Access Compliance Report

Public Rights-of-Way

Intersection ID: 43357	Main Street: PROSPERITY_VIEW_DR	Cross Street: WOODLAND_COMMONS_DR	Location: E
ADA ID: C2A1FEA5ACDD	Ramp Type: PerpDiag	Initial Pass/Fail: Fail	Overall Compliance: No
			Severity Score: 21.25

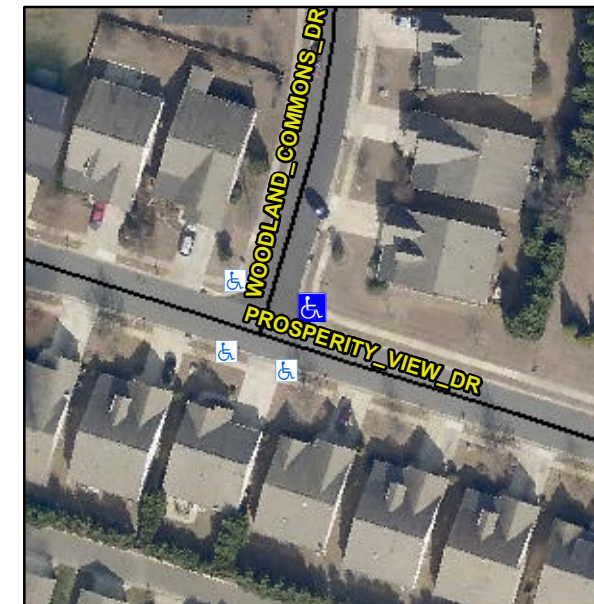
Not Found, R304.5.1, R304.2.2

Compliance	Description	Data	Compliance	Description	Data
N/A	Ramp Length (in)	47.0	No	Ramp Slope (%)	9.6
No	Ramp Width (in)	38.5	Yes	Ramp XSlope (%)	0.9
N/A	Flare Type LT	N/A	N/A	Flare Type RT	N/A
N/A	Flare Slope LT (%)	N/A	N/A	Flare Slope RT (%)	N/A
N/A	Flare Traversable LT?	N/A	N/A	Flare Traversable RT?	N/A
N/A	Landing Length (in)	N/A	N/A	DWS Provided?	N/A
N/A	Landing Width (in)	N/A	N/A	DWS Contrast?	N/A
N/A	Landing Slope (%)	N/A	N/A	DWS Length (in)	N/A
N/A	Landing X Slope (%)	N/A	N/A	DWS Full Width?	N/A
N/A	Landing Curb? (Y/N)	N/A	N/A	DWS Offset (in)	N/A
N/A	Shared Landing?	N/A			
N/A	Gutter Ponding?	N/A	N/A	Gutter Slope (%)	N/A
N/A	Gutter Lip Ht (in)	N/A	N/A	Gutter X Slope (%)	N/A
N/A	Painted X Walk1?	No	N/A	Painted X Walk2?	No
	X Walk 1 Direction	To NW		X Walk 2 Direction	To SW
N/A	X Walk 1 Width (in)	N/A	N/A	X Walk 2 Width (in)	N/A
	X Walk 1 Slope (%)	2.6		X Walk 2 Slope (%)	5.5
	X Walk 1 X Slope (%)	1.1		X Walk 2 X Slope (%)	2.9

Remove & Replace Curb Ramp With Two New Directional Ramps or Equivalent.
